Kind : Maintenance instruction.

Effectivity : All ASW 20s and ASW 20 Ls.

ASW 20
Maintenance Instruction
D

Alexander Schleicher
Segelflugzeugbau
6416 Poppenhausen

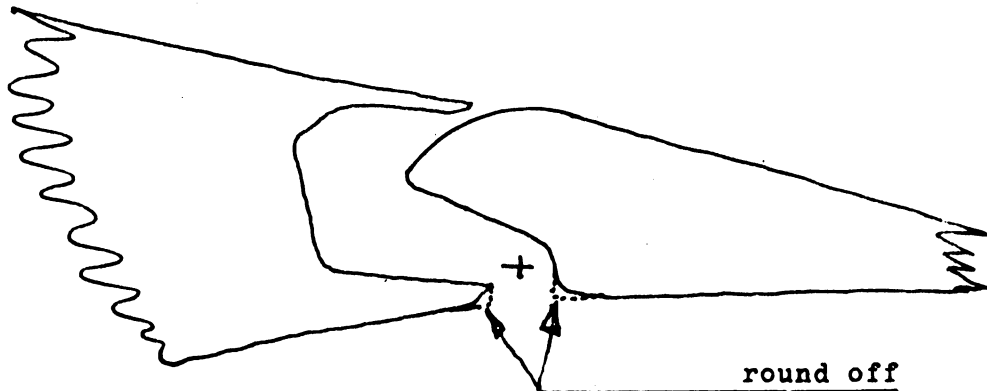
- A) High frequency turbulence in wind shear layers.
- B) Strong turbulence.
- C) Shaking of the control stick by the pilot or blows with the hand to the side of the stick.
- D) Airbrake cover plates being not completely closed.
- E) Fluttering tape (lower wing surface). Apparently this may happen if the tape - over a greater part of the wingspan - is no longer folding inwards into the control gap but if it is folding to the outside; then it has the same effect as an airbrake which is a little extended. The folding of the tape to the outside also causes considerable losses in performance, especially in flap position 1 (-11°).

1. The airbrake over center lock is tightened according to Maintenance Instruction C for ASW 19 and ASW 20. The notes given in the ASW 20 Operations Manual on page 39 (ASW 20 L; page 43) must be observed.
2. Fluttering tape as well as any tape folding to the outside between the control hinges is replaced by new tape. For serial production 38mm tape is now used. It has been found that it pays if the edges of the wing and the controls are carefully rounded off so that the tape folds more easily to the inside of the gap.

When applying the tape, you must take care that the tape is not tightened too much when the flap is full up (see ASW 20 Flight Manual page 42, for ASW 20 L see page 46), i.e. a deflection of 49mm measured at the trailing edge of the flap root rib, or when the aileron is full up, i.e. a deflection of 32mm measured on the outboard end of the trailing edge. As the tape may shrink a bit with moisture (it is made of cotton), it must not be too tight in these configurations otherwise full aileron deflections in flap position 1 are no longer possible.
